Service Bulletin

Bulletin No.: PIC5360B

Subject: Intermittent No Crank No Communication To High Speed LAN Modules

Models: 2010 - 2013 Chevrolet Camaro

2503475

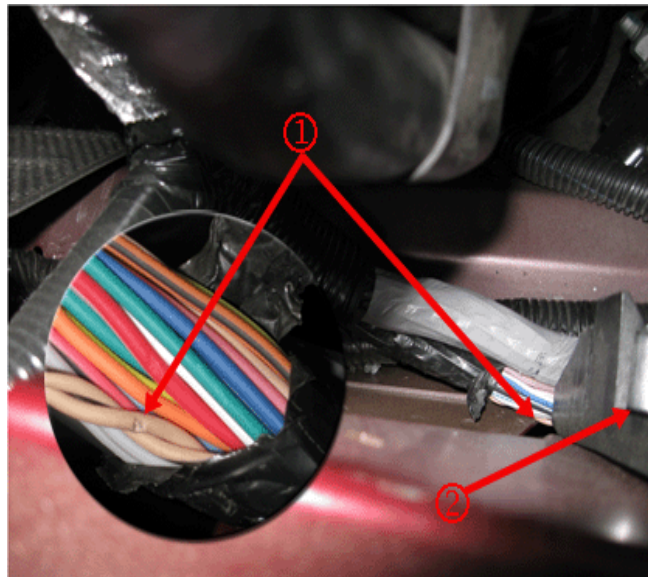
There are two (2) locations on the vehicle to inspect for this concern depending on what options it is equipped with. The first area of concern is the engine wiring harness (1) under the ECM (2). Technicians are to check for possible chaffing of this wiring harness on the inner fender panel. An example of this concern can be seen in the photo below.

Repair the wiring, install conduit on this area of the harness, and relocate the harness away from the panel to protect it from future damage.

3226239

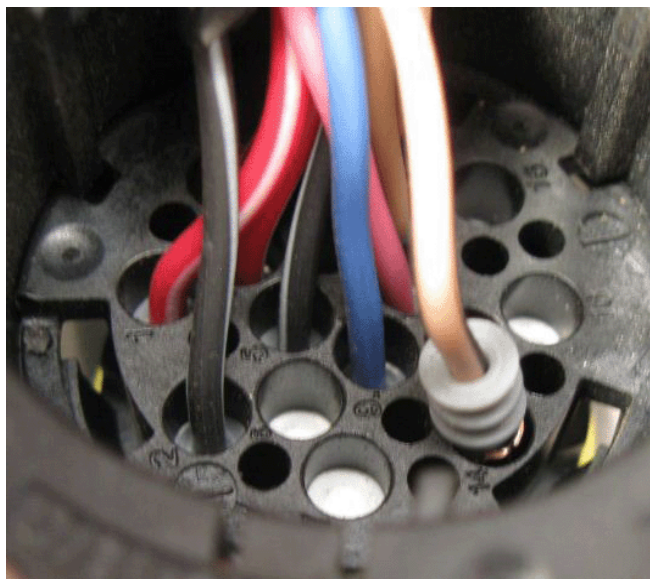
The second area of concern relates to vehicles equipped with an automatic transmission only. Reports from the field have shown that a HSLAN circuit terminal may not be seated properly in the round TCM connector located in the transmission. Technicians are to inspect this TCM connector for any data line circuits that may be not fully seated in the plastic connector. If this concern is found, carefully inspect the condition of both halves of the plastic connector

The two photos below show an example of circuit 2500 backed out of the TCM connector. Be sure to inspect ALL terminals in this connector while it is disconnected.

as well as both the male and female terminals. If the female terminal was simply not seated correctly, push on the wire until the terminal clicks back into position. Lightly tug on the wire to make sure it is fully seated. If it pulls back out, replace the terminal and/or connector as needed. After reinstalling the connector to the TCM, lightly tug on the wire again to make sure it did not become disengaged during reassembly. If the male terminals or the TCM half of the connector is damaged, the entire TCM will require replacement. This module is internal to the automatic transmission assembly.
